TENNESSEE VALLEY AUTHORITY

February 19, 1985

Docket Nos. 50-390
50-391

DISCUSSION OF OPEN ITEMS

Temperature Profile of Insulated Barton Transmitter
During Postulated MSLB In Valve Vault

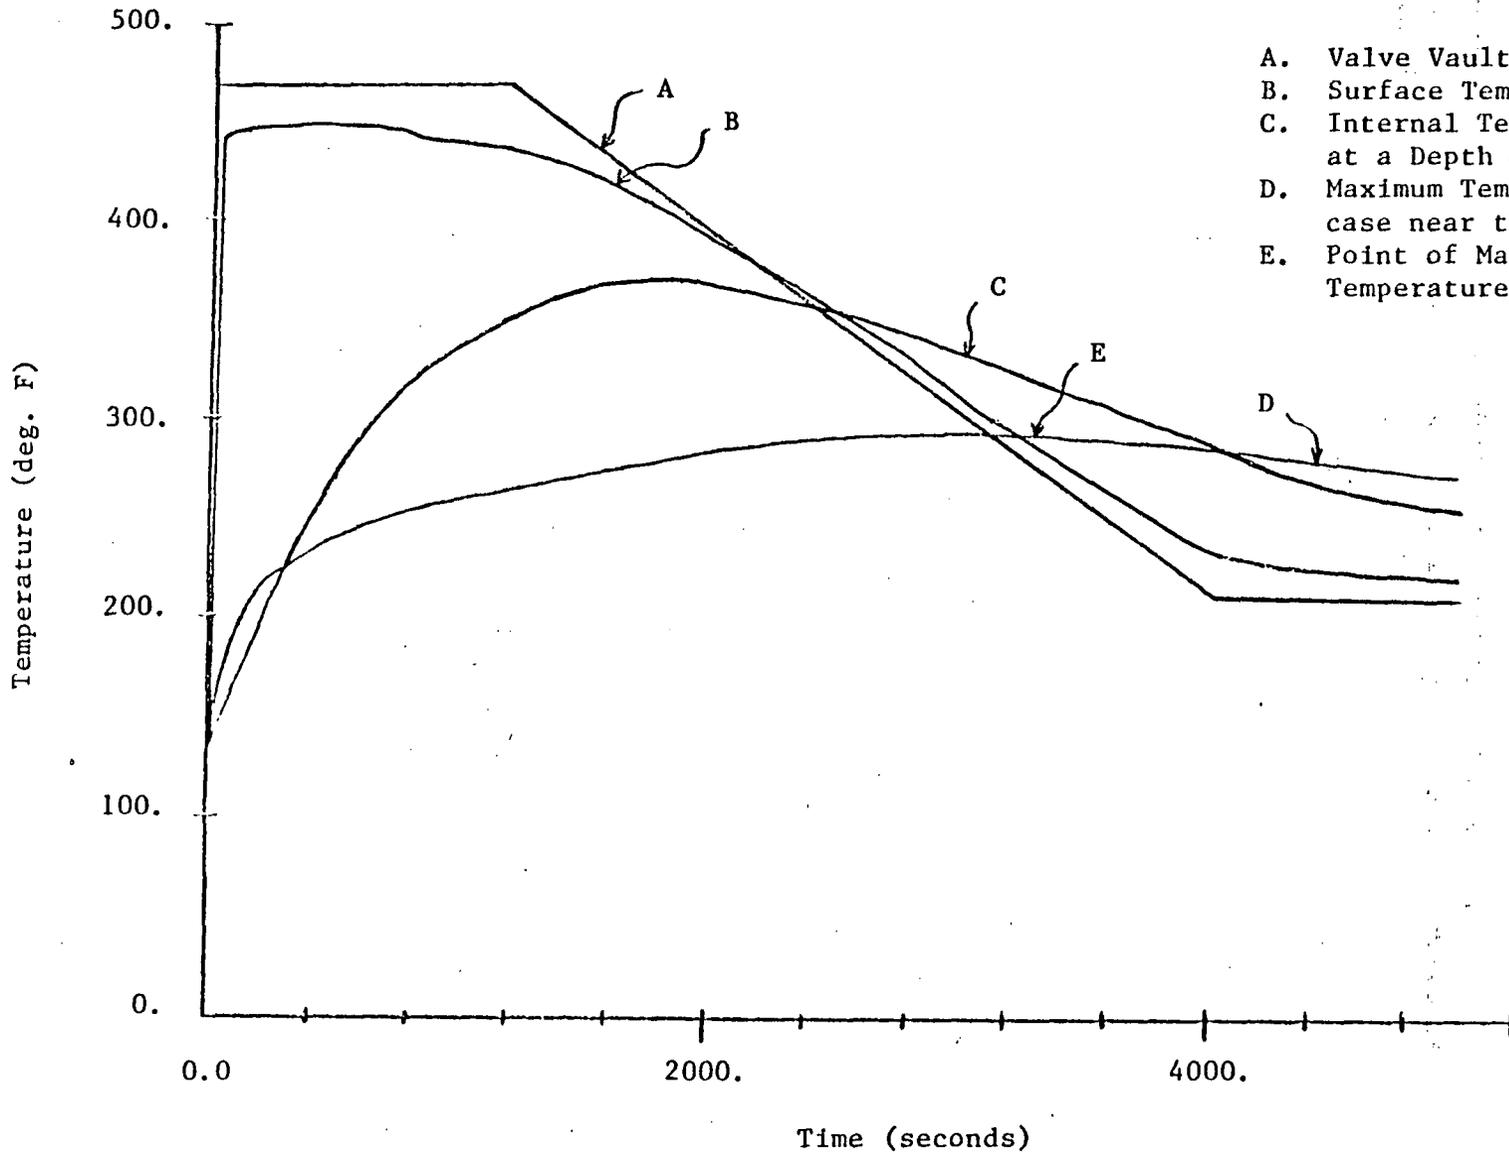
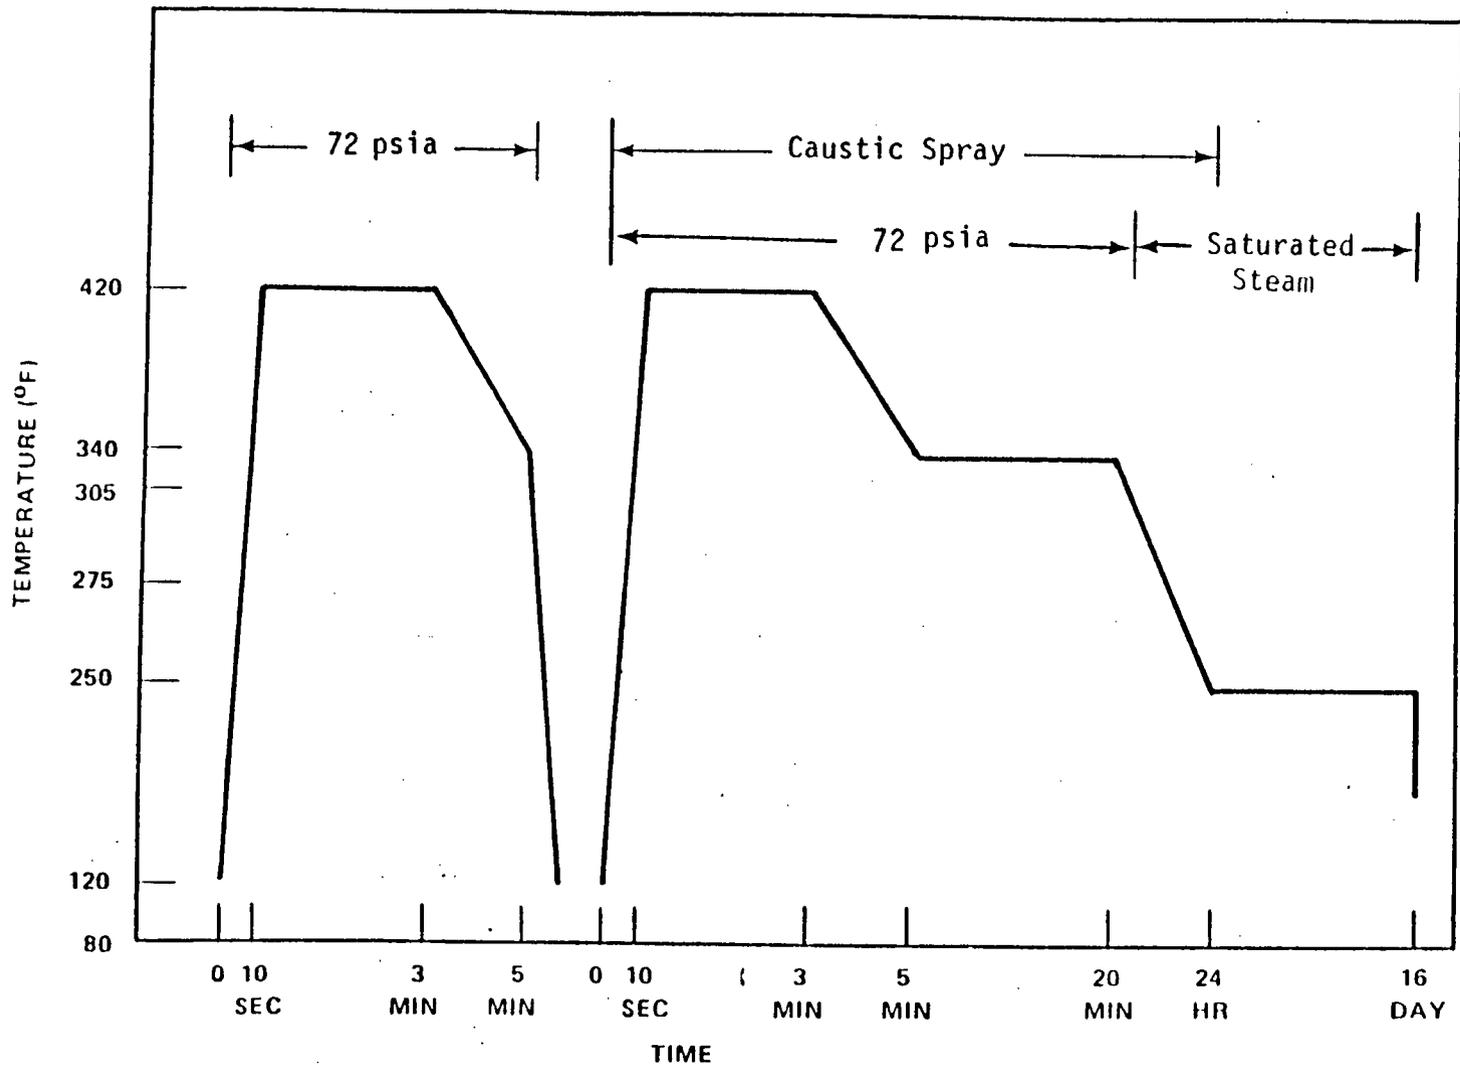
Barton transmitters are used to provide postaccident monitoring (PAM) of environmental conditions in the valve vault at Watts Bar Nuclear Plant (WBN). The environmental conditions which these PAM instruments were expected to experience were based upon an analysis which failed to consider the effects of steam superheating following steam generator tube uncover during a main steam line break (MSLB). The inclusion of steam superheating produces peak environmental temperatures which exceed current PAM instrument qualification temperatures by 30 to 40°F. These instruments were recently insulated with a custom-designed 2-inch-thick thermal cover to protect them from the increased temperatures. A thermal analysis was performed to verify that temperatures seen by the insulated instrument are less than the environmental qualification profile. The results of this analysis are discussed below.

The thermal analysis of a PAM transmitter was performed using a two-dimensional axisymmetric HEATING5 (reference 1) model of the transmitter casing. The valve vault atmospheric temperature profile, which was used as the temperature forcing function input into the HEATING5 code, was constructed assuming that (1) peak superheating in the steam generator occurred instantaneously at time zero, (2) the duration of the peak atmospheric temperature was 20 minutes, and (3) the peak environmental temperature used in the analysis was 470°F. The preceding assumptions conservatively maximize the amount of heat transferred to the PAM instrument since (1) superheat is not generated until steam generator tube uncover, (2) after the onset of superheat, a finite period of time will be required (depending on break size and auxiliary feedwater flow rate) before peak superheat and consequently peak temperature occurs; (3) auxiliary feedwater flow will be terminated by operator action at 10 minutes, thereby ensuring that superheat will be terminated almost immediately for a large break and within the 20-minute timeframe for small breaks; and (4) the peak atmospheric temperature used in the analysis was 20°F higher than was generated using vendor-supplied data. Therefore, the temperature forcing function is believed to be conservative. Additionally, the 1.5-watt heat generation rate of the instrument was included as an internal forcing function to simulate the operational heat load.

The heat transfer boundary conditions for the PAM instrument model were based upon the Uchida correlation during condensate heat transfer and upon convective heat transfer after the insulation surface temperature exceeded the steam saturation temperature. The maximum Uchida heat transfer coefficient (282 Btu/hrft²°F) was conservatively assumed until the insulation surface temperature reached saturation and then a forced convection heat transfer coefficient based upon vendor-supplied blowdown data was used during the remainder of the blowdown. After the blowdown period, the heat transfer coefficient was chosen to be the larger of the turbulent free convection coefficient or the minimum Uchida heat transfer coefficient (2.0 Btu/hrft²°F) for the remainder of the transient.

The results of the analysis are depicted in Figure 1 and clearly demonstrate that the peak temperature seen by the PAM transmitter casing (curve D) remains well within its environmental qualification profile (Figure 2). The maximum transmitter case temperature (point E on Figure 1) is 292.7°F and occurs at the thermal short created by the 1-1/2-inch mounting bracket connection to a 1/4-inch steel mounting plate (see Figure 3). Curves depicting typical insulation temperatures are shown on Figure 1 to illustrate that cooldown is occurring at the end of the transient.
